RIVERDALE CITY COUNCIL AGENDA
CIVIC CENTER - 4600 S. WEBER RIVER DR.
TUESDAY – OCTOBER 20, 2026

Body:	City Council
Topic:	**CarMax Auto Superstores – Final Site Plan Application**
Department:	**Community Development**
Director:	Brandon Cooper
Staff/Presenter:	Brandon Cooper
Contact:	bcooper@riverdaleutah.gov

On June 16, 2026, CarMax Auto Superstores, represented by Kristen Cowan from CenterPoint Integrated Solutions, submitted an application for a commercial Site Plan approval for the CarMax auto dealership located at 671 W 4400 S (parcel no. 06-356-0001) in the newly adopted Commercial (C-3) zone. The applicant seeks to construct a pre-owned auto dealership on approximately 5.5 acres, with the associated buildings, parking, landscaping, and infrastructure. FZD Riverside Flats, LLC is the current owner of the property and has provided owner authorization. A public hearing is not required to consider this site plan proposal.

PROJECT NO.	25-078
DATE	21 AUG 2026
SHEET TITLE	SITE LAYOUT PLAN
SHEET NO.	C3.0

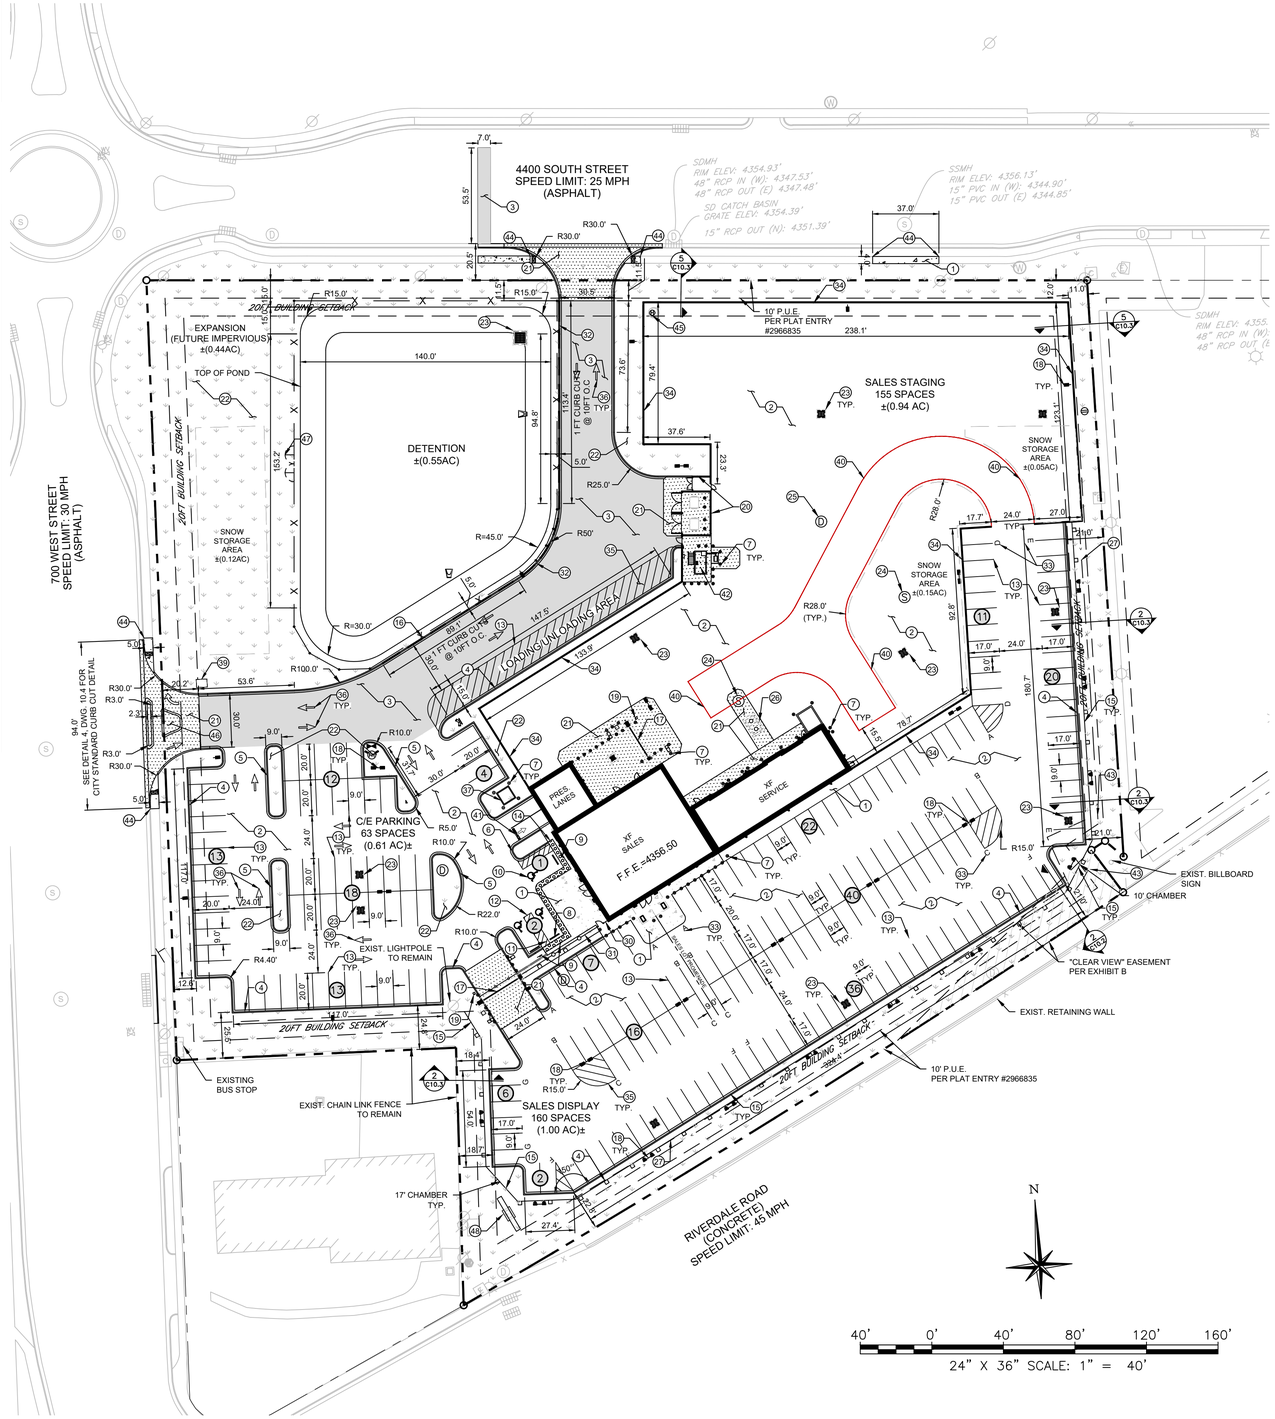
DATE	COMMENTS	CORRECTIVE ACTION	STATUS
08/14/2026	**C3.0 Site Plan**	See redlined notes on attached plan set	Not Resolved
		Show how the fuel tank will provide secondary containment for spills.	Not Resolved
		Provide a designated snow storage area that is sized between 10-15% of the paved area that will be plowed.	Not Resolved

PROJECT NO.	25-078
DATE	21 AUG 2026
SHEET TITLE	SITE UTILITY PLAN
SHEET NO.	C4.0

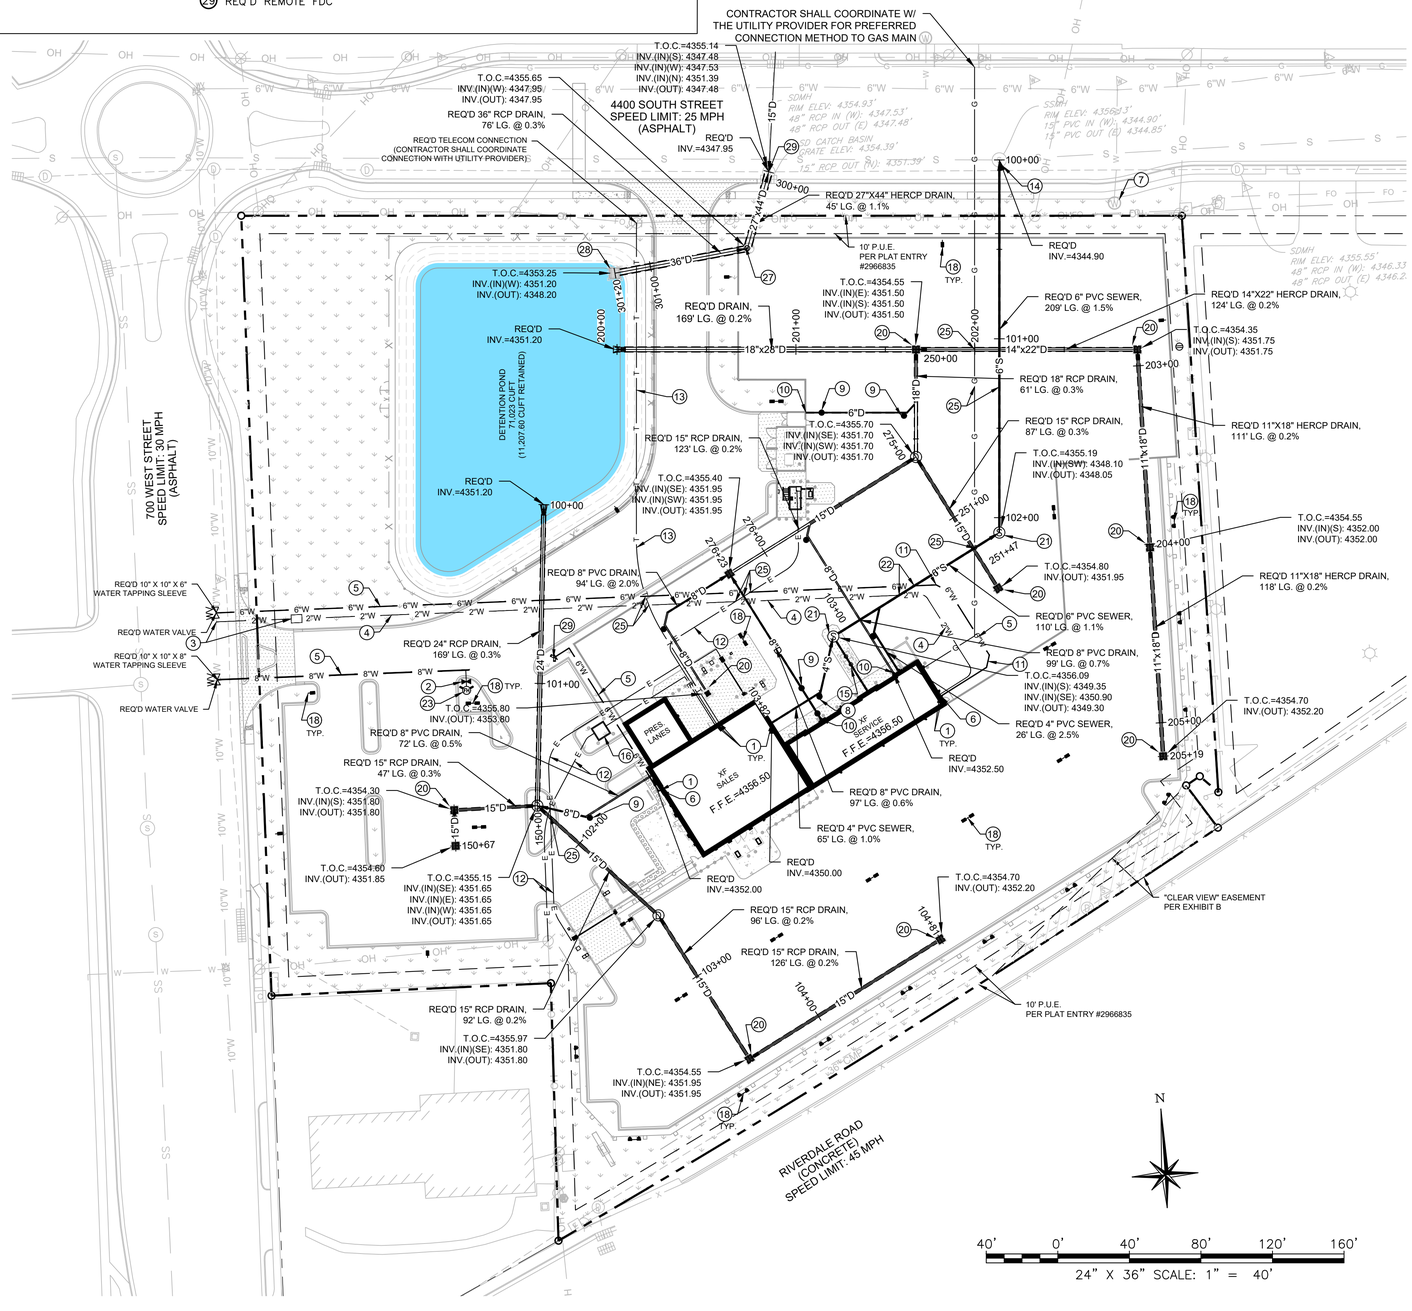
C4.0 Utility	Provide the top-of-grate elevation for the basin outlet. The detail and the plans currently cross-reference each other without showing the actual elevation.	Not Resolved
		When the river flows at full capacity, the water level reaches the top of the outlet pipe into the river. Given your proposed inverts, there is a risk of backwater flooding into your basin. Please address this issue.	Not Resolved
		It appears the 36" storm water pipe will bore through the concrete bench in the manhole. Please address this.	Not Resolved
	C2.01Grading	The Water Quality Management section on page 7 of the Drainage Calculations report states that the 80th-percentile water quality volume will percolate in 47.33 hrs. Please provide calculations showing how this was determined.	Not Resolved
		Provide calculations for the orifice size design. My calculation show an orifice with a 6"diameter and 1.74 feet of head would provide a flow of 1.29 cfs which is too much over the 1.1 cfs allowed for the site. Please reduce the orifice size.	Not Resolved
